**Complaint - Camera Image of Front Camera is Blurred, Water Stains on the Camera Lens:
Replace Front Camera and Front Wire Harness if Necessary (149/21)**

Model Line: **Taycan (Y1A/ Y1B)**

Equipment: **Park Assistent inkl. Surround View (I-no. KA6)**

Front camera

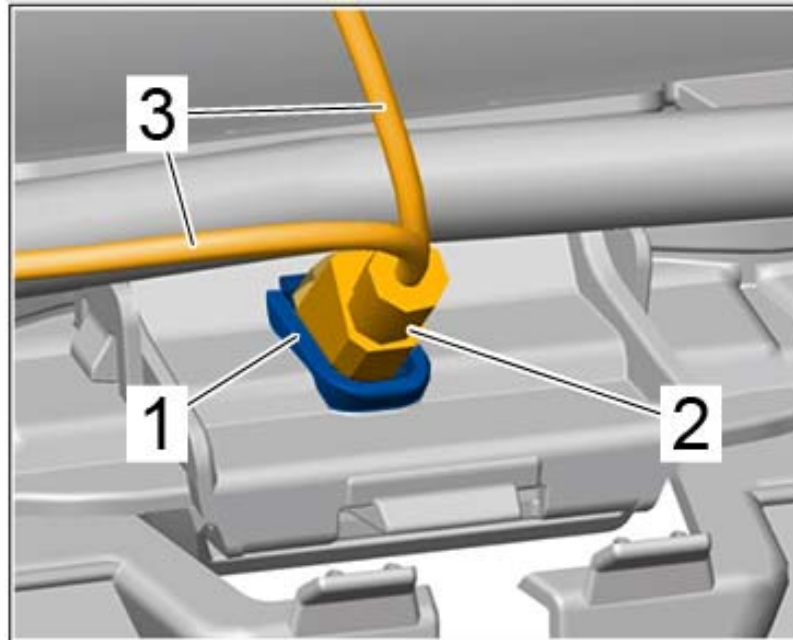
Information: The customer complains about a blurred camera image or water stains on the camera image of the front camera. This may be caused by water seeping in at the **electric plug connection** for the front camera, resulting in soiling or damage.

A new type of rear wire harness with an improved seal at the plug connection for the reversing camera is available.

Rear wire harnesses with the **part number index G or H** (Part Nos.: 9J1971104G, 9J1971104H) already have the improved seal in the plug connection for the reversing camera. If the rear wire harness has a **part number index A-F**, it must also be replaced.

Action required: In the event of a complaint, replace the front camera and, depending on the type of wire harness, also replace the front wire harness if necessary.

- 2 Check wire harness and replace it if necessary.
- If the part number of the front wire harness corresponds to one of the **part numbers 9J1971095DA, 9JA971095AS or 9J1971095DC**: The new type of wire harness is already installed. Continue with ⇒ *Technical Information '916919 Subsequent work'*.

- If the part number of the front wire harness corresponds to one of the **part numbers 9J1971095AS, 9JA971095L or 9J1971095BC**: Replace wire harness with the relevant wire harness with the new type of wire harness: ⇒ *Technical Information '916919 Parts required'*
